**CORK COUNTY COUNCIL**  
**WESTERN DIVISION**  
**WATER SERVICES**

**APPLICATION FOR WASTE**  
**WATER DISCHARGE LICENCE**  
**DUNMANWAY**

**REPLY TO REGULATION 18(3)(b)**  
**NOTICE**

**Re: D0160-01 - Dunmanway Waste Water Discharge Licence Application**  
**- Reply to Notice in accordance with Regulation 18(3) of the Waste Water**  
**Discharge (Authorisation) Regulations 2007**

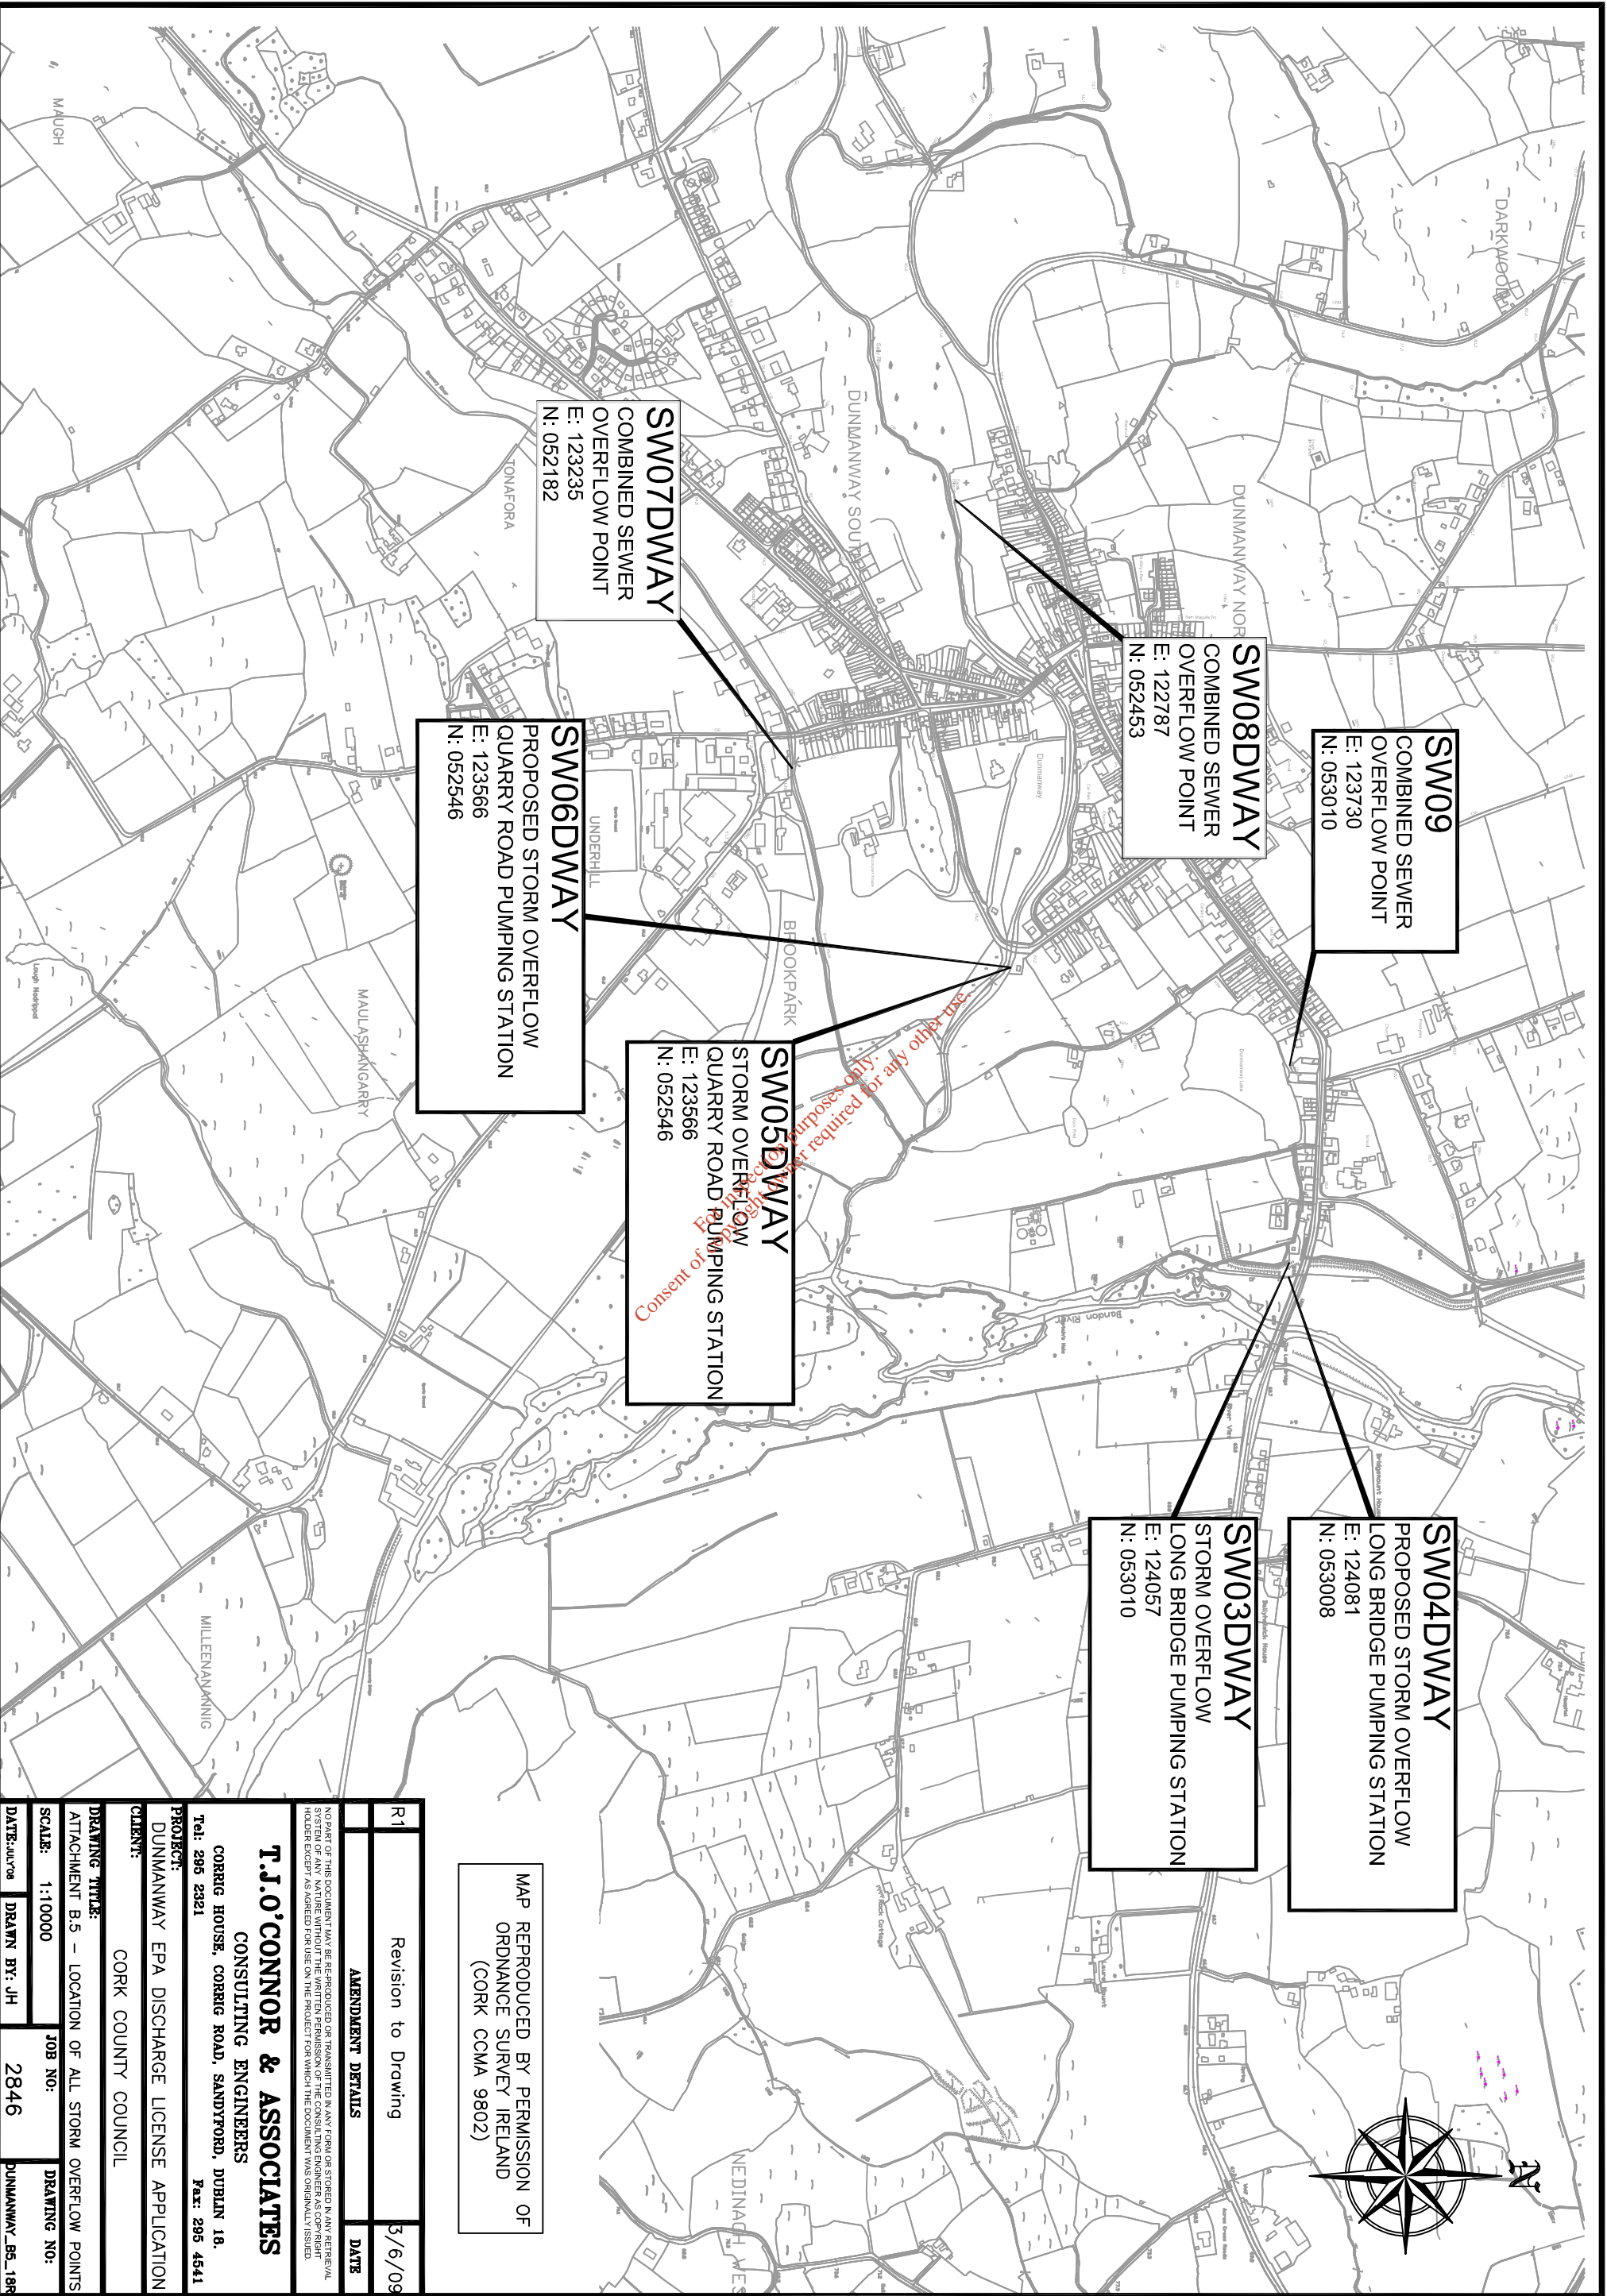
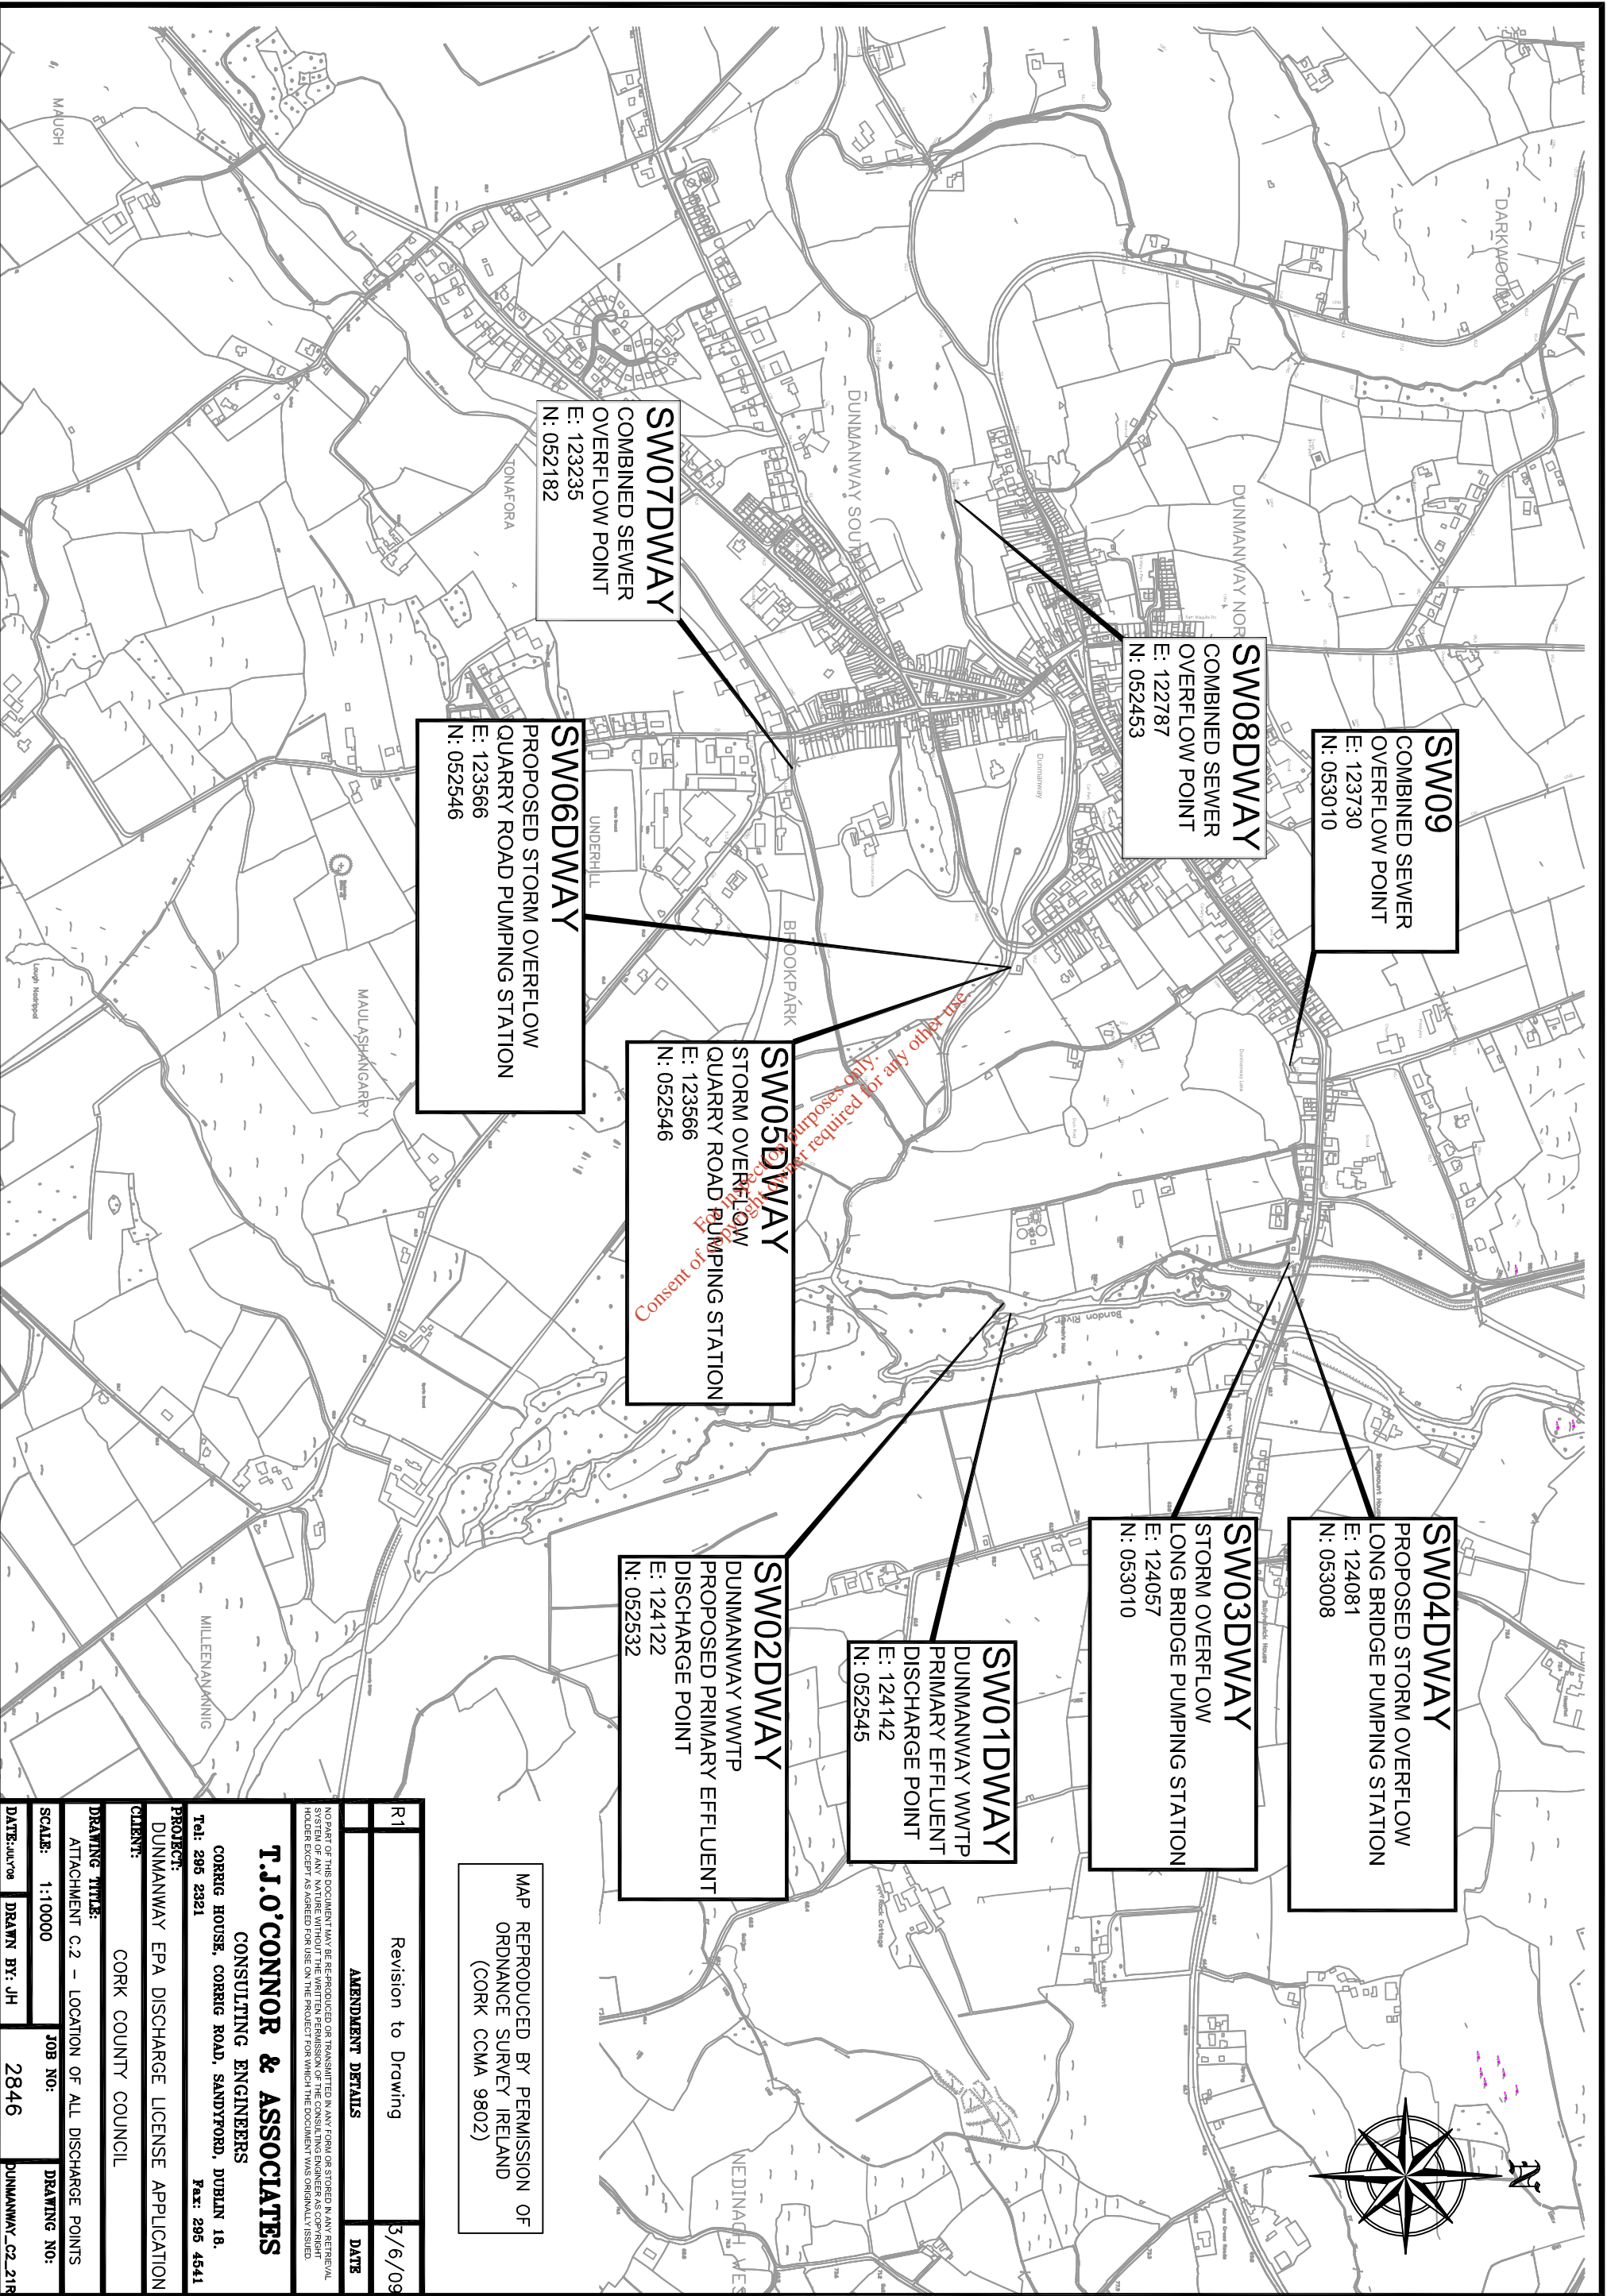
R1	Revision to Drawing	5/6/09
<b>AMENDMENT DETAILS</b>		
<small>NO PART OF THIS DOCUMENT MAY BE REPRODUCED OR TRANSMITTED IN ANY FORM OR STORED IN ANY RETRIEVAL SYSTEM OF ANY NATURE WITHOUT THE WRITTEN PERMISSION OF THE CONSULTING ENGINEER AS COPYRIGHT HOLDER EXCEPT AS AGREED FOR USE ON THE PROJECT FOR WHICH THE DOCUMENT WAS ORIGINALLY ISSUED.</small>		
<b>T.J.O'CONNOR &amp; ASSOCIATES</b>		
CONSULTING ENGINEERS		
CORRIG HOUSE, CORRIG ROAD, SANDYFORD, DUBLIN 18.		
Tel: 295 2321 Fax: 295 4541		
PROJECT: DUNMANWAY EPA DISCHARGE LICENSE APPLICATION		
CLIENT: CORK COUNTY COUNCIL		
DRAWING TITLE: CORK COUNTY COUNCIL		
ATTACHMENT B.5 - LOCATION OF ALL STORM OVERFLOW POINTS		
SCALE: 1:10000	JOB NO: 2846	DRAWING NO:
DATE: 5/6/09	DRAWN BY: JH	DUNMANWAY_B5_18R
